**PAUL HALAJIAN
ARCHITECTS**

ADDENDUM

PROJECT: **Clovis Landmark Square
Senior Activity Center and Transit Center**

ADDENDUM#: **04**

PROJECT NUMBER:
2016-39
SHEET NUMBER:
AD4-01

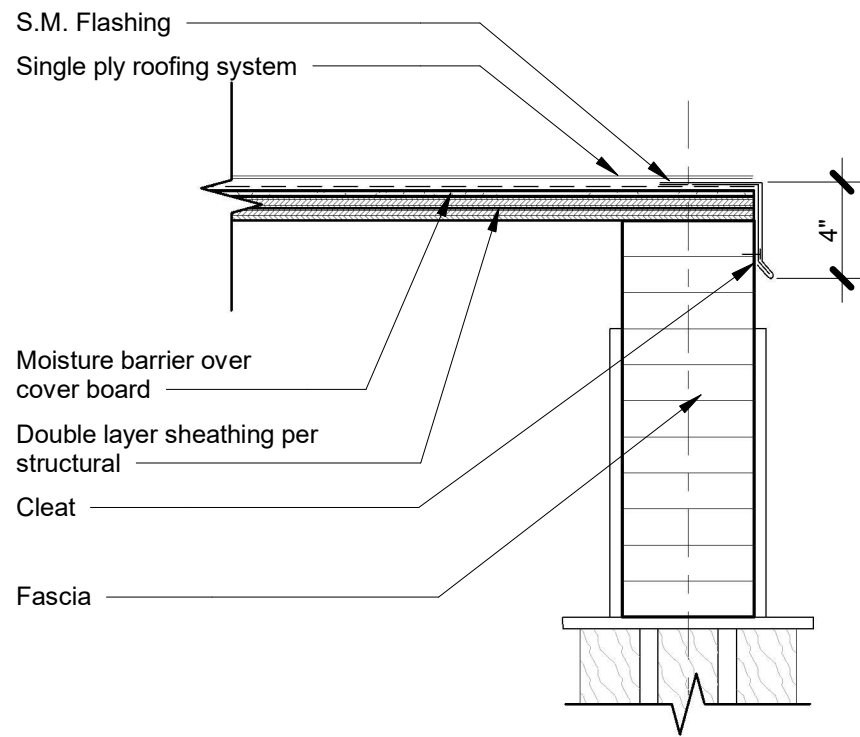
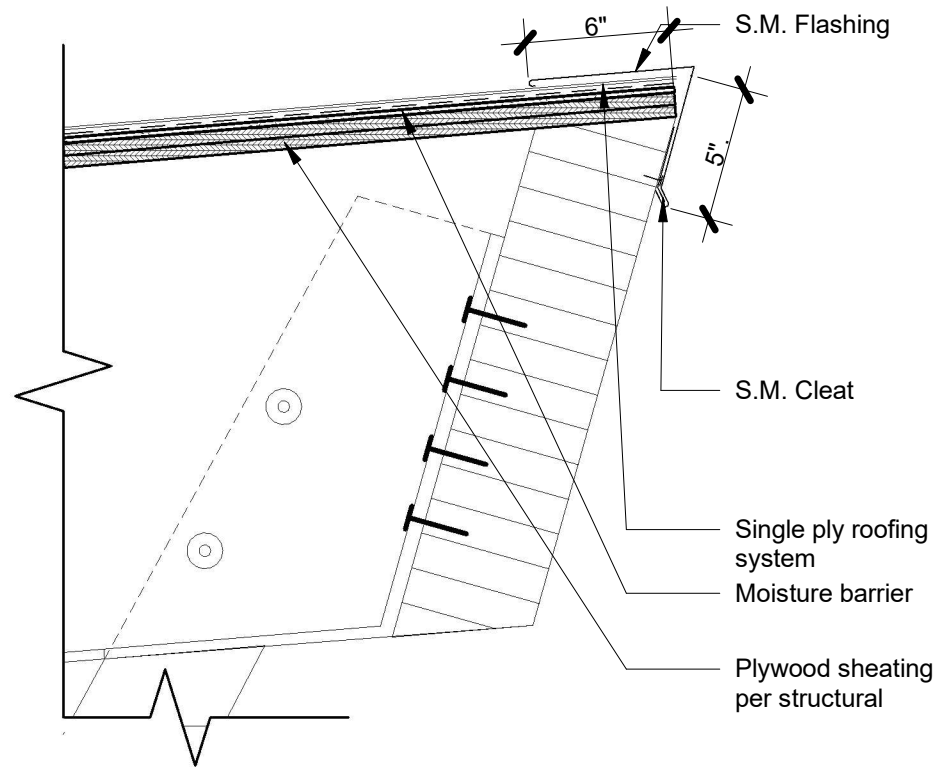
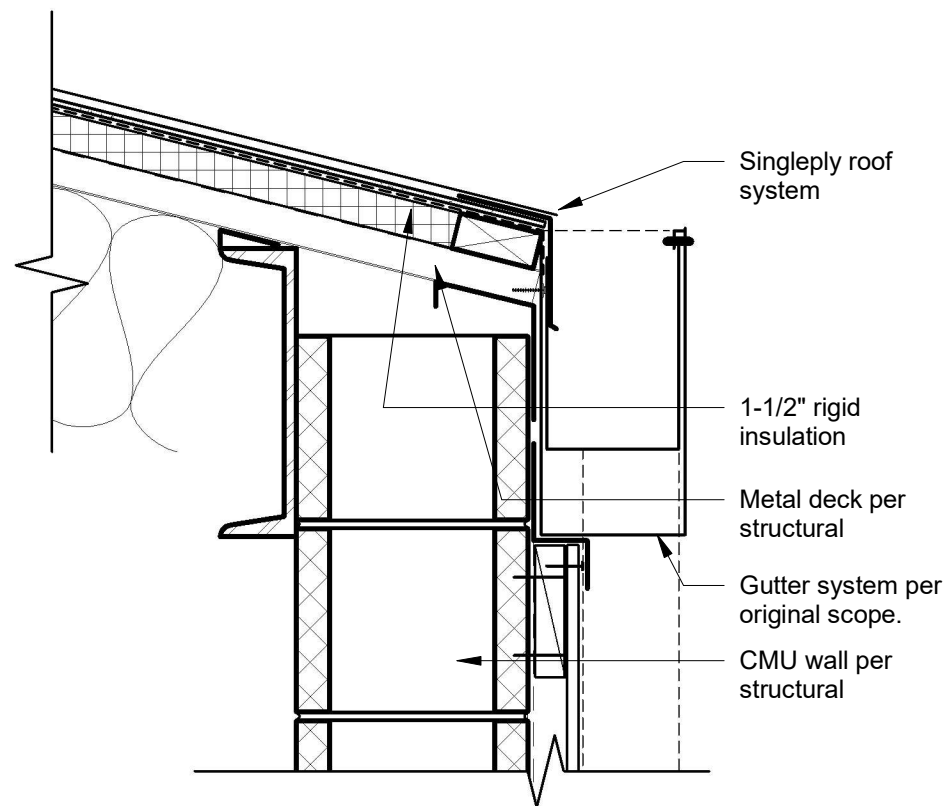
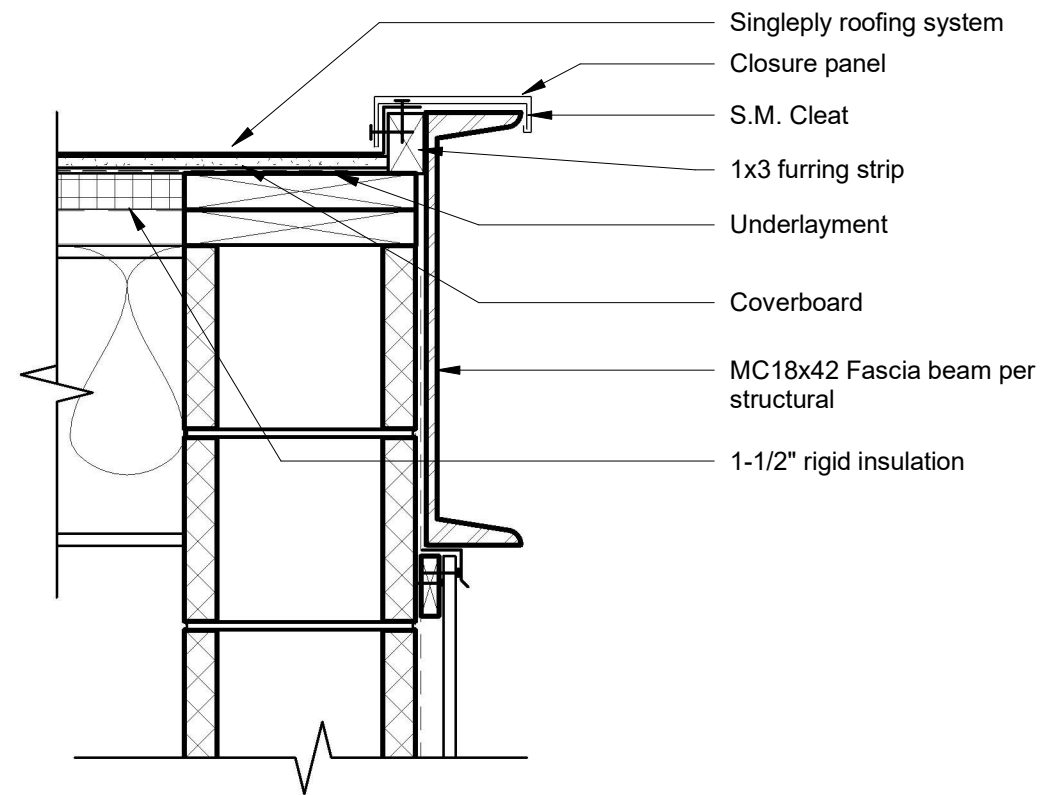
- a. **RFI Question:** Specifications Section 01 2300 – Part 3.1-C indicates Alternate No. 3 to eliminate Metal Roofing as shown on Drawings and replace with Single Ply roofing system throughout. Please provide Alternate Roof Plan with appropriate Detail callouts and Roof Detail Sheets showing Single Ply Roofing system in lieu of Metal Roofing.

- b. **RFI Response:** Refer to Drawing AD4-01 for supplemental details at roof edge conditions.

SHEET NUMBER:
AD4-A240

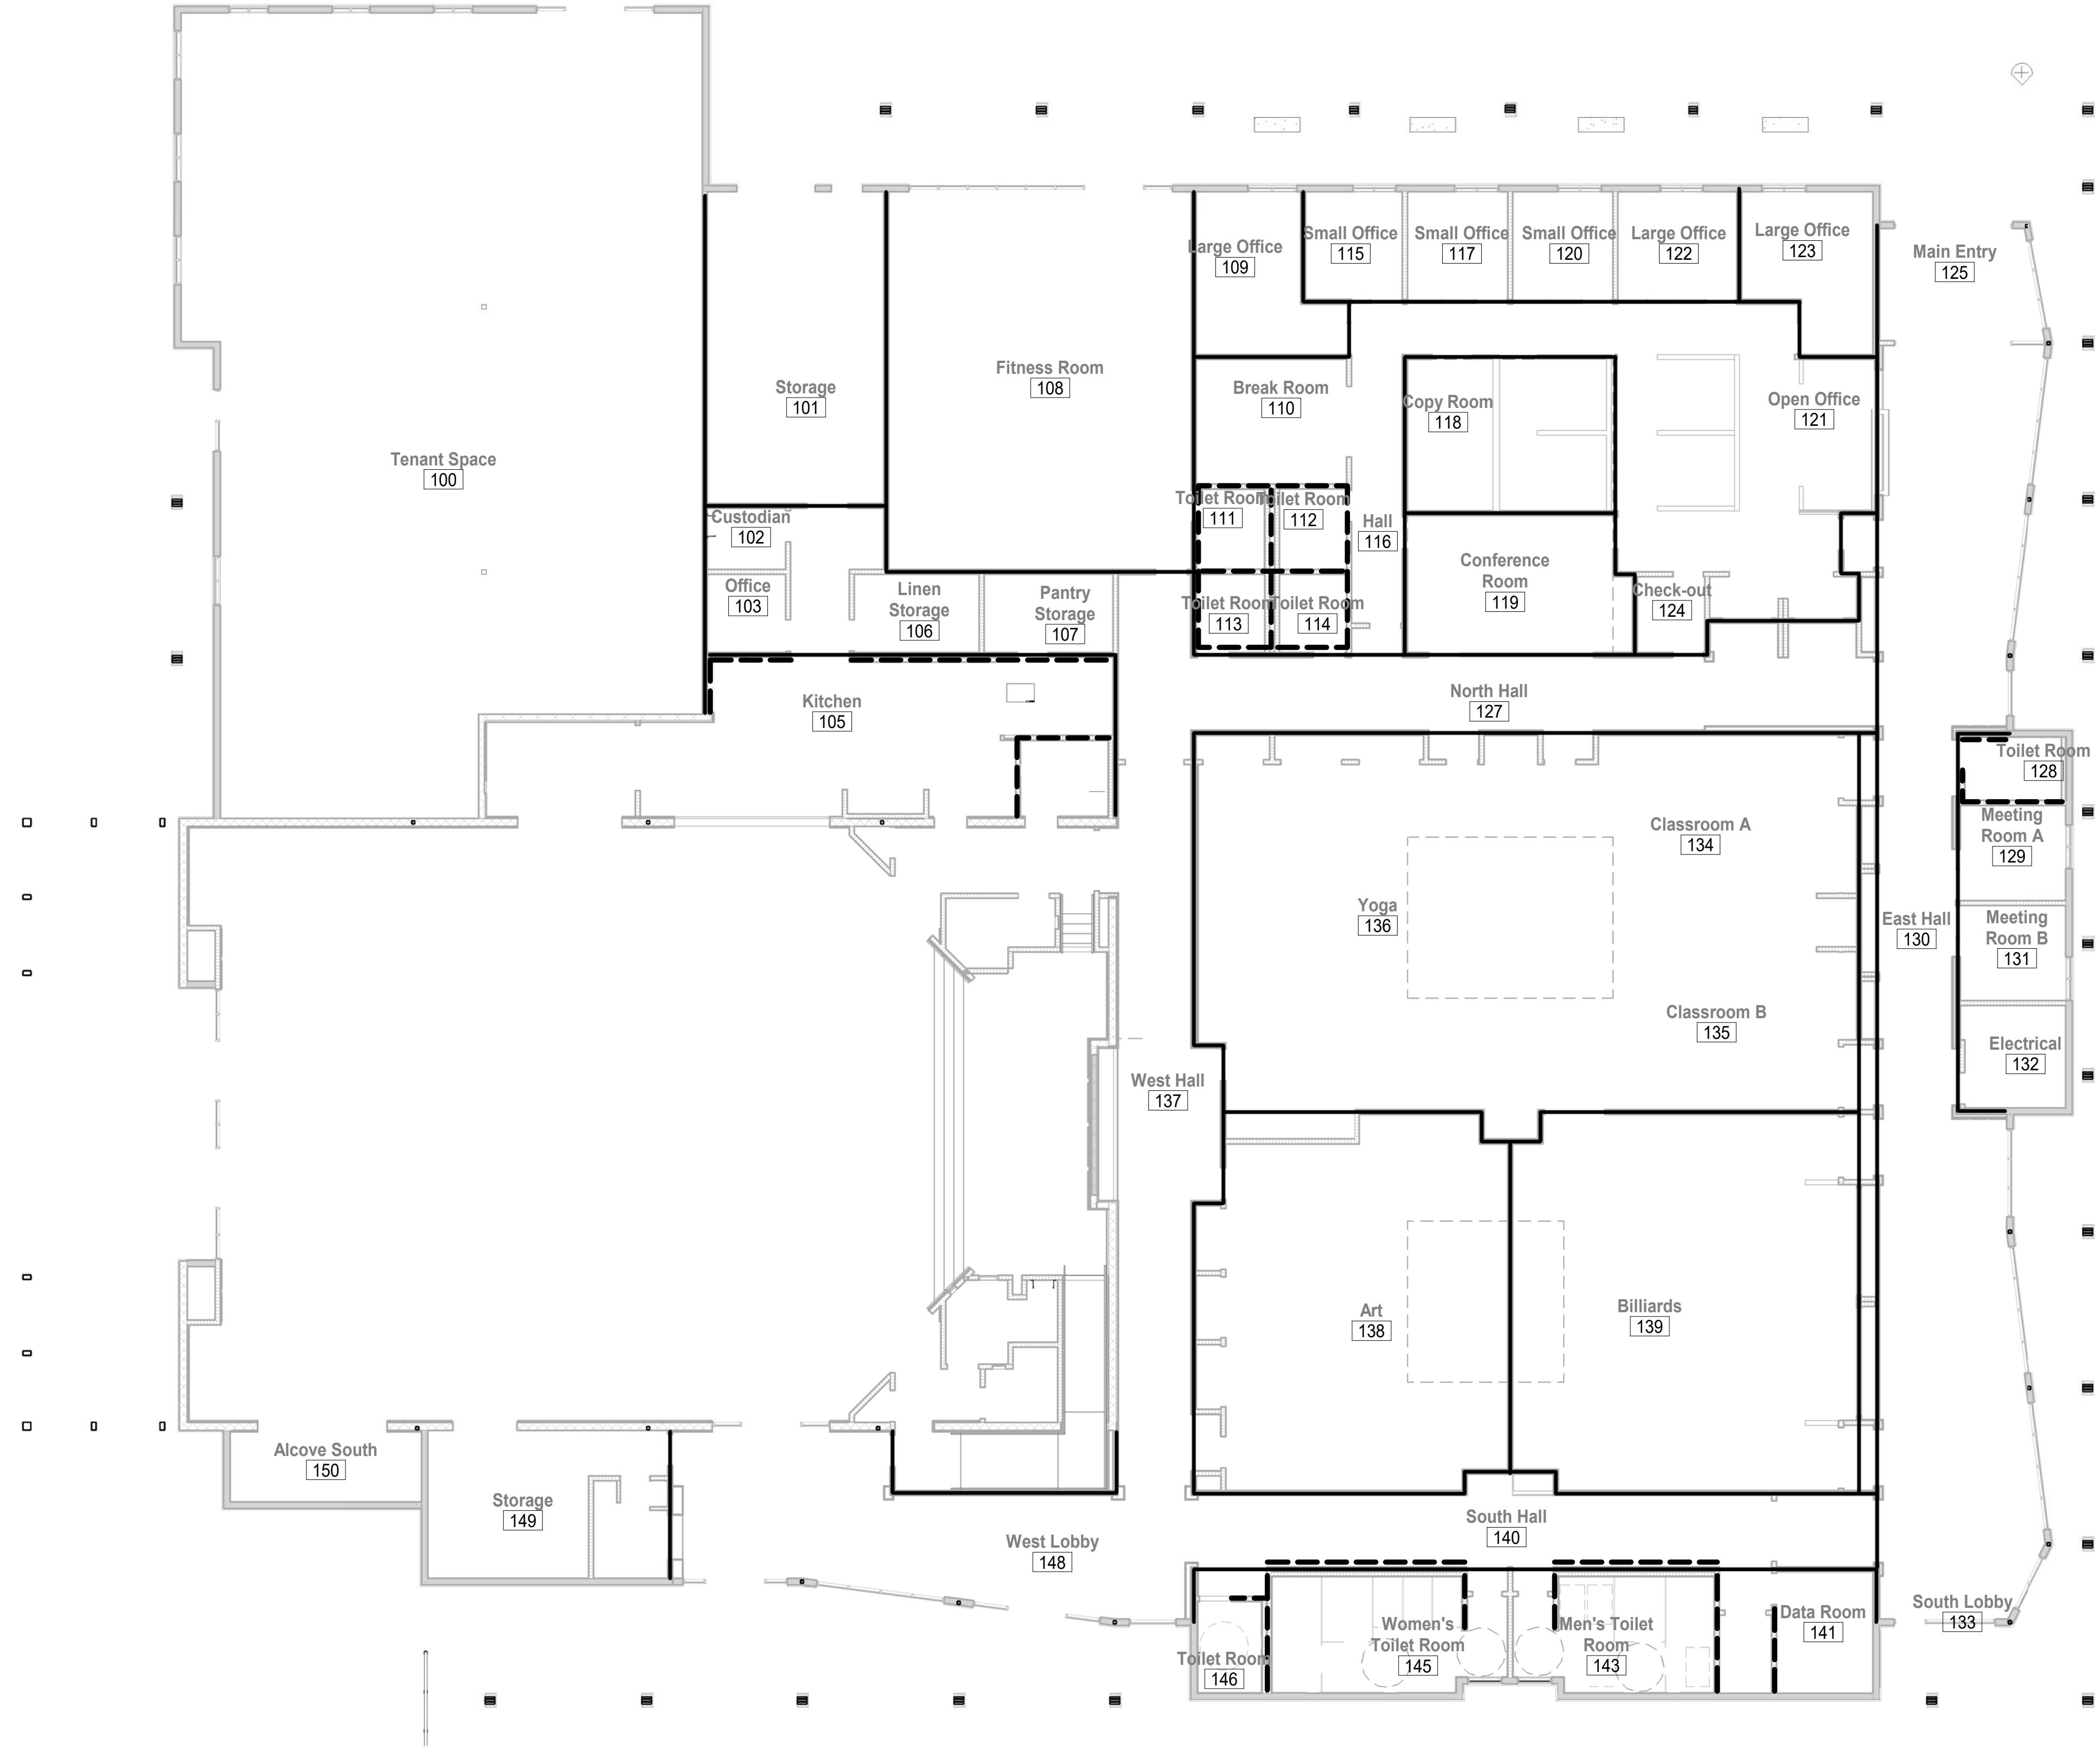
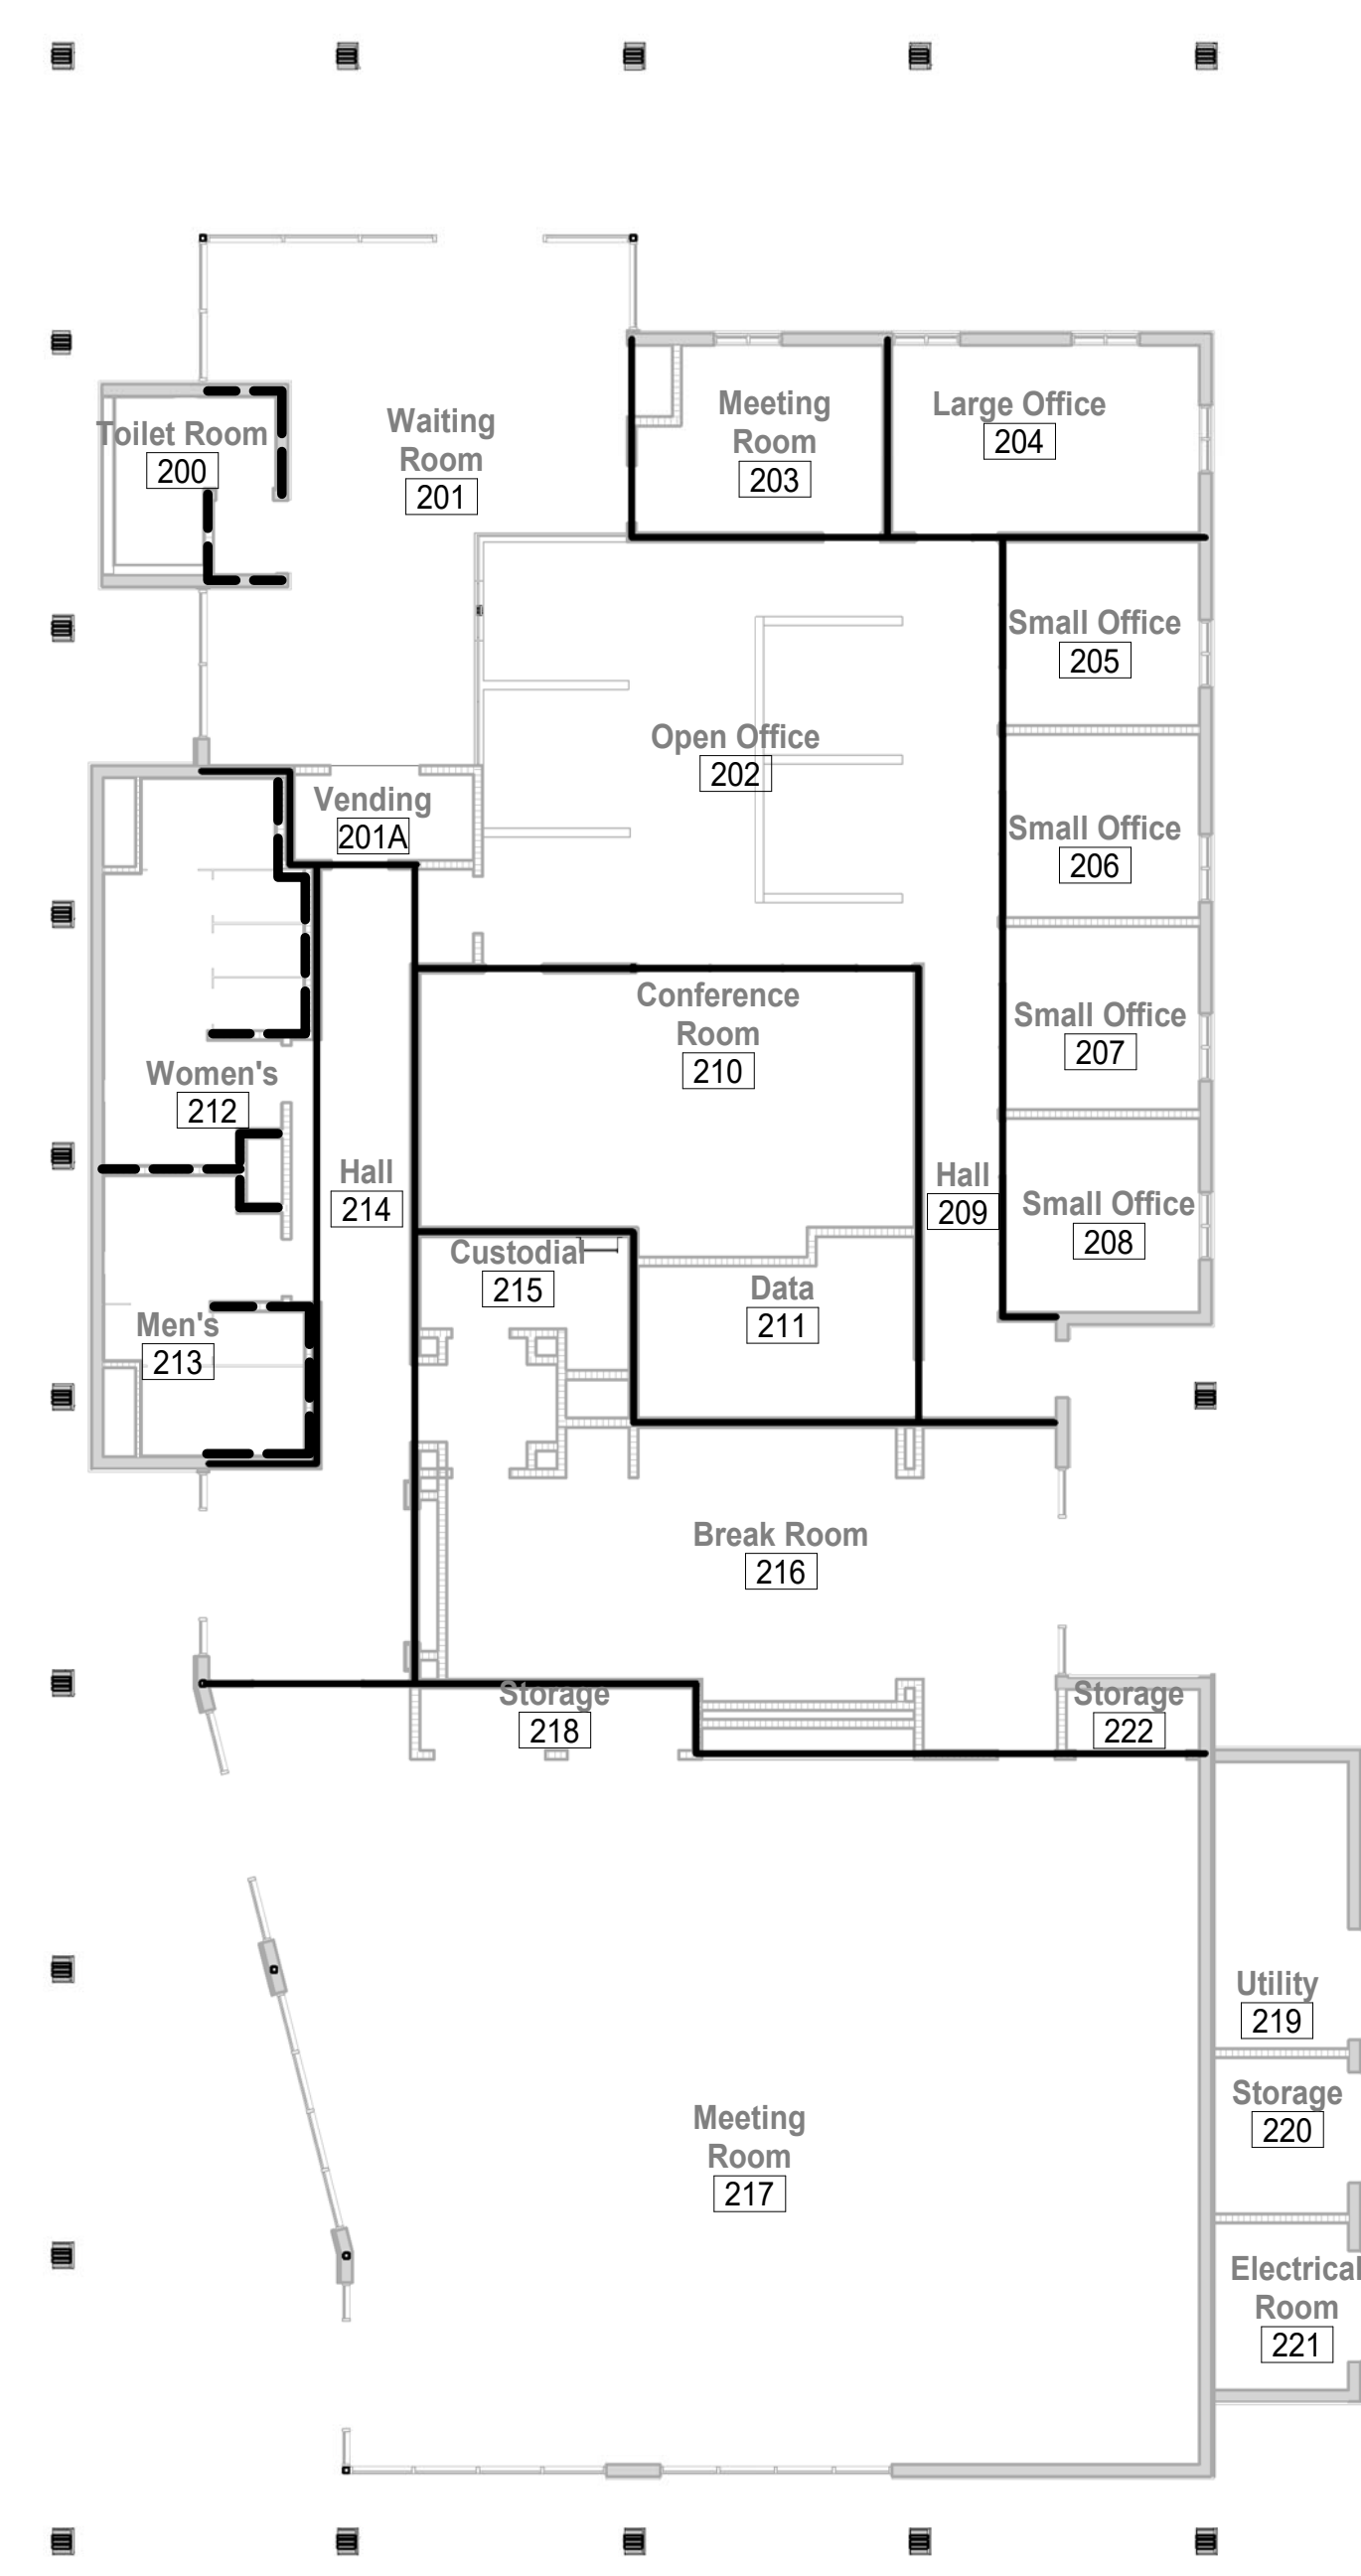
- a. **RFI Question:** Regarding interior non-bearing stud wall framing:
 - a) Are studs to be framed full height to the roof deck or only to 6" above ceiling height? Architectural details (Ex: 4,5/A904) suggest full height framing to roof deck but Structural sections (Ex: D/S401) suggests framing only to 6" above ceiling. Please advise.
 - b) If studs are to be framed to 6" above ceiling height, do studs need to be braced to roof deck?
 - c) If bracing is required, please advise as to the bracing requirement
- b. **RFI Response:** Refer to attached Sheet AD4-A240 – Full Height Wall Framing Plan.

- a. **RFI Question:** Please provide a plan indicating where cast-in-place concrete curbs are to occur at any stud wall locations.
Exterior Walls, Restroom Walls, Etc.
- b. **RFI Response:** Refer to attached Sheet AD4-A240 – Full Height Wall Framing and Interior Curb Plan.

1. Walls indicated with solid black line to be full height walls framed to underside of roof. Refer to Structural Drawings for Bearing wall locations.
2. Full height wall to have (1) layer of gypsum board on both sides of wall assembly. At soffit locations, it is acceptable to have (1) layer of gypsum board on full height soffit if framing is extended to underside of roof.
3. Provide Acoustical insulation at Toilet Rooms, Offices, Meeting Rooms, Classroom/Instructional Areas, and framed wall at east side of Tenant Space 100.
4. Refer to Sheet A200 for fire rated wall locations.
5. Dashed lines indicate 6" curbs at interior walls.
